SUGAR HILL GREENWAY CONCEPT LIVABLE CENTERS INITIATIVE VIRTUAL OPEN HOUSE #2 SUMMARY

September 9, 2020 | 6:00 to 7:00 pm | WebEx and Dial-in

Figure 2. Proposed Route - SR 20 West

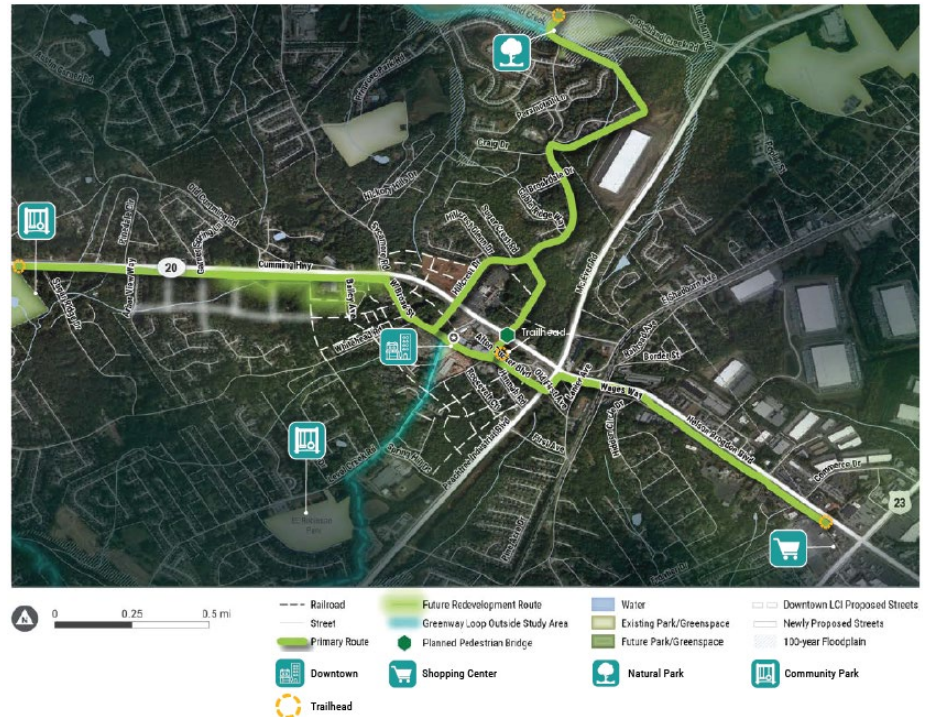
- *Participant: Is it possible to put the shade trees between the greenway and the road to act as more of a buffer? I love the trees, but it would be great to see them on the other side.*

- *Participant: Safety from vehicle traffic – guardrails/posts along the road side*
 - *TD: See above*
- *Participant: Too little space between sidewalk and road.*

- *Participant: Friendship's speed is 45 mph, which might be something to bring SR 20 down to*
 - *TD: The speed limit is currently 45 mph in this area.*

- *Participant: As bikers it can be frightening too along that route*

- *Participant: Yes, agree about the trees.*
 - *Toole Design (TD): We would love to put trees in the buffer between the shared use path and the road. Unfortunately, the Georgia Department of Transportation (GDOT) regulates the size and type of objects you can put immediately next to a state route, and that includes trees. This is what they call a clear zone, which is meant to provide recovery space for vehicles that exit the roadway. The size of tree that is allowed in that space is up to a 4-inch caliper, which basically means you cannot put any tree that would ultimately grow large enough to provide shade and a better sense of protection.*

- *TD: Wherever possible, the width of the buffer will be maximized. However, because there is a steep incline with guard rails and multiple retaining walls on the south side of the road, the available width in many areas is constrained. In some locations, additional right-of-way would have to be acquired.*

Figure 3. Proposed Route - Hillcrest

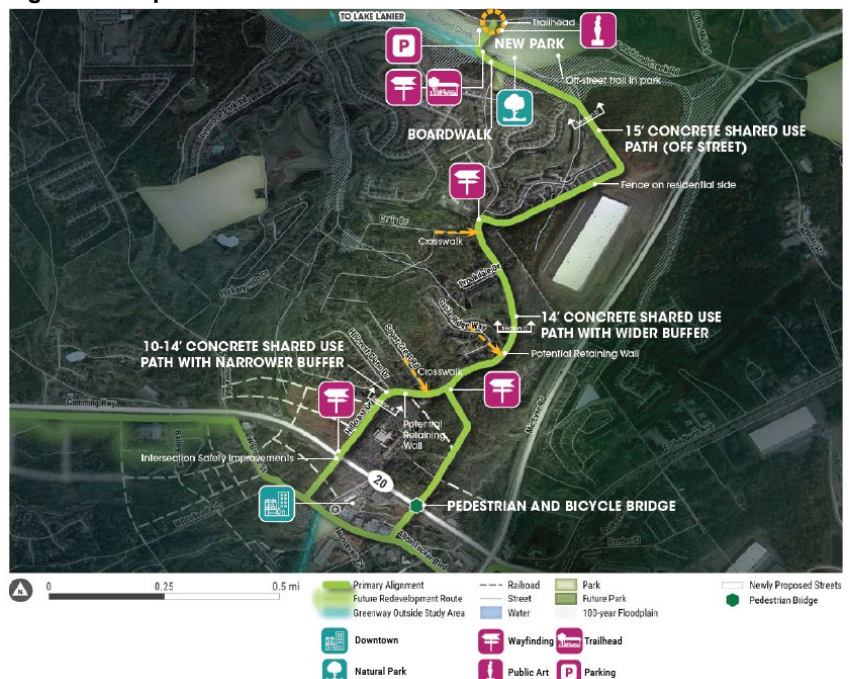
- *Participant: As residents of Primrose Creek, there is about 200 feet between my property and the creek. This proposed trail will reduce that width and allow users of the greenway closer to my home. Will there be any walls, privacy walls, or barriers to protect the residents from users of the walkway? It would be ideal to have the trail on the north side of the creek as a barrier for the homeowners.*

- *Participant: Since this is getting people "into nature," I'm hoping you'll make extra effort to remove a minimal amount of mature trees so that the residents on Buckthorn Drive can maintain some of their privacy.*

- *Participant: Regarding the Hillcrest section, what will the setback be from the properties on Buckthorn Dr?*
 - *TD: It is recommended to add a fence on the residential side of the greenway through the wooded area to give more privacy and a clear delineation. There will be a wooded landscape buffer as well. The exact width of the buffer between the greenway and residential properties varies along the corridor and will be determined in the design phase. Neighbors will have additional opportunities to weigh in on features like buffers and lighting as the project moves into the detailed design phase. There are various options for safety patrols, call boxes, or geocoded 911 markers that could also be considered in the design.*

- *TD: This project did not include a survey of the land, which will be included in the design phase. A survey is needed to identify the locations of specific mature or specimen trees. The intention is to retain the natural setting and trees with minimal disruption.*

Figure 4. Proposed Route - SR 20 East

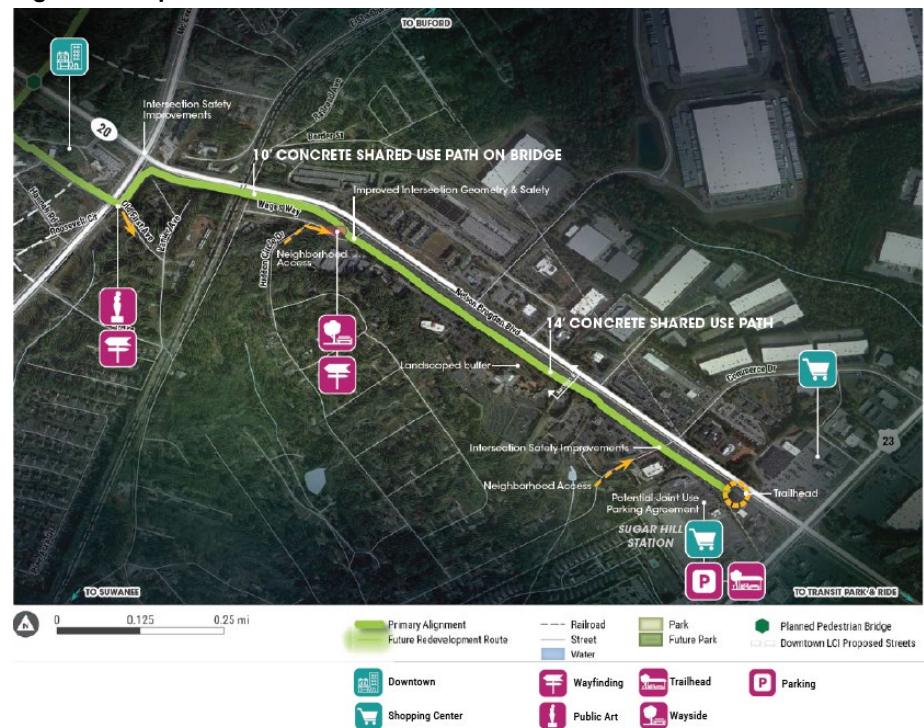
- *Participant: Will the new path be straight or curvy?*
 - *TD: In this section, there is enough right-of-way to make it curvy.*
